To: Kristopher Byrd, Well Construction and Compliance Section Manager
From: Travis Kelly, Well Construction Compliance Coordinator
Subject: Review of Water Right Application G-19156
Date: January 6, 2022

TO: Water Rights Section Date 11/22/2021
 FROM: Groundwater Section Joe Kemper
 Reviewer's Name
 SUBJECT: Application G- 19156 Supersedes review of NA
 Date of Review(s)

A. GENERAL INFORMATION: Applicant's Name: Kathleen and David Reed County: Coos

A1. Applicant(s) seek(s) 1.0 cfs from 2 well(s) in the South Coast Basin,
Coos Bay subbasin

Well Location Map

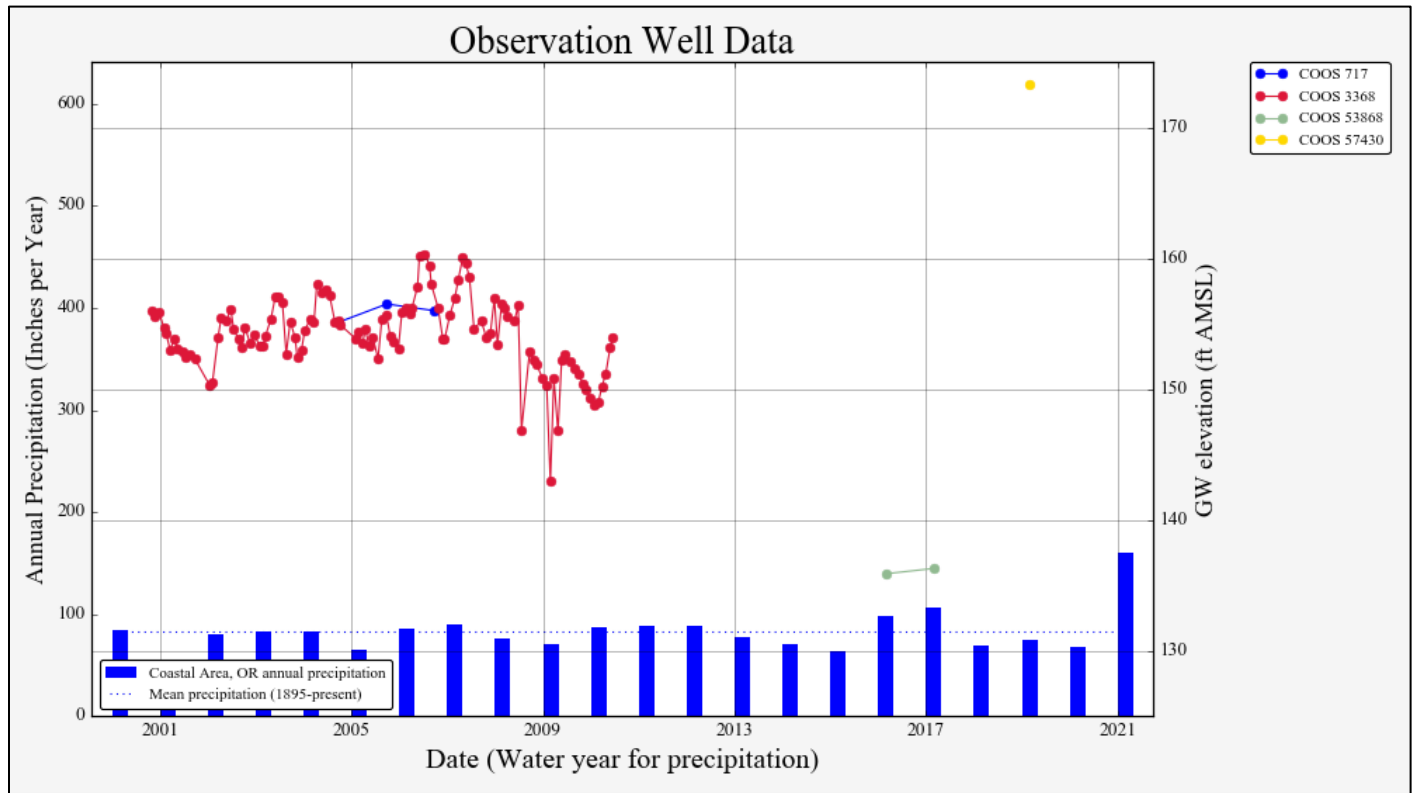
Additionally, Well 1 accesses an unconfined aquifer within ¼ mile from Twomile Creek and its unnamed tributary, resulting in an assumption of hydraulic connection and the potential for substantial interference (PSI) as per OAR 690-009.

Theis Distance Drawdown Modeling

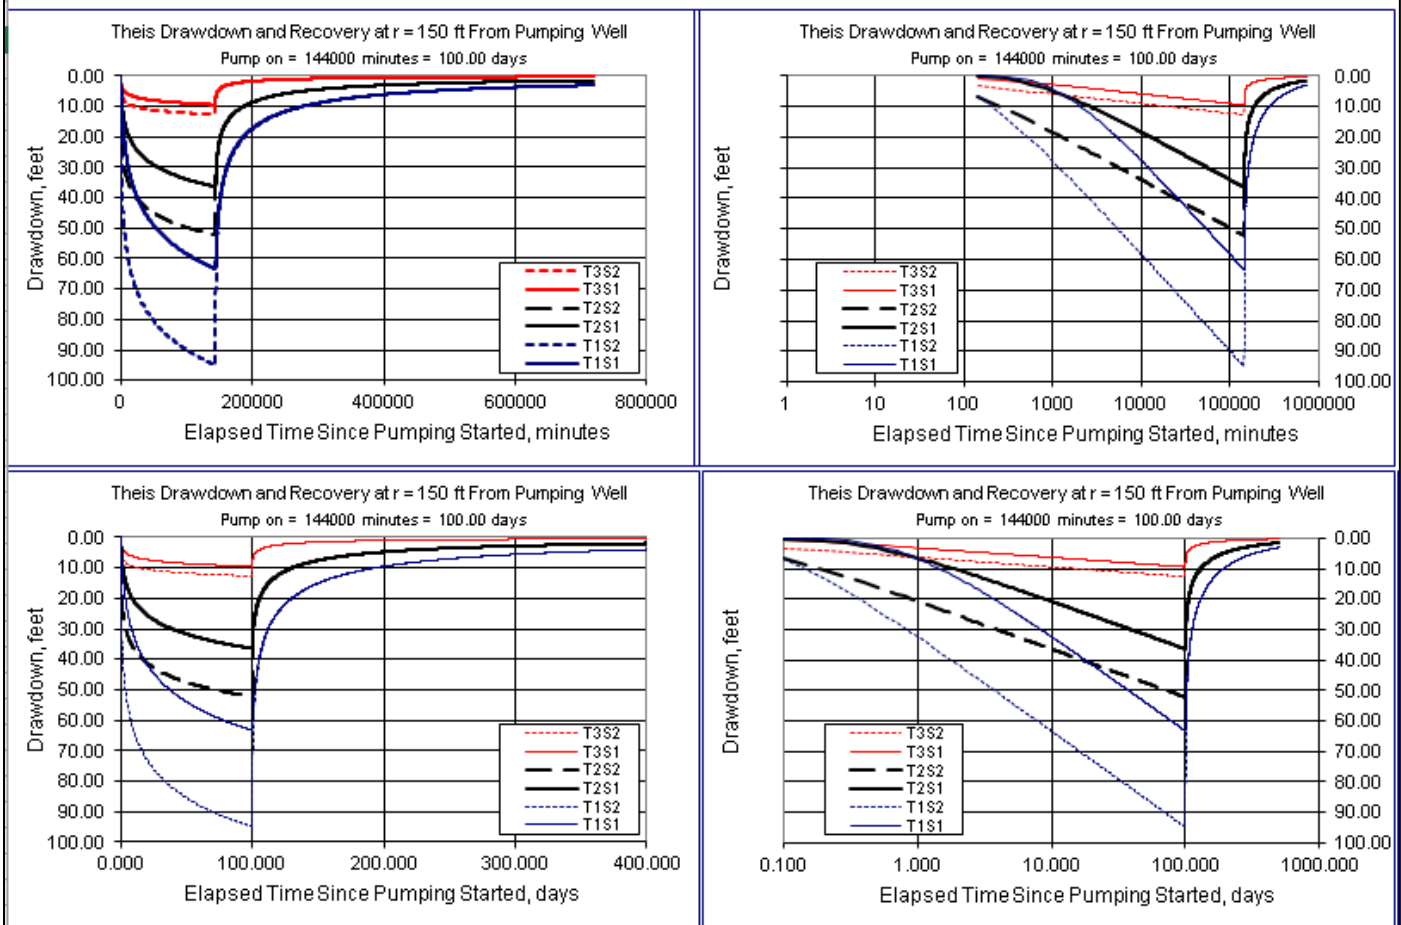
The proposed use will likely cause well-to-well interference with adjacent senior groundwater users, the closest of which are likely are exempt-use wells on tax lot 701 and 1301. A Theis distance drawdown model estimates that the proposed use will likely cause more than 35 feet of seasonal drawdown at these wells, which would trigger the proposed 25-foot decline permit conditions. Thus, the proposed use will likely injure prior water users.
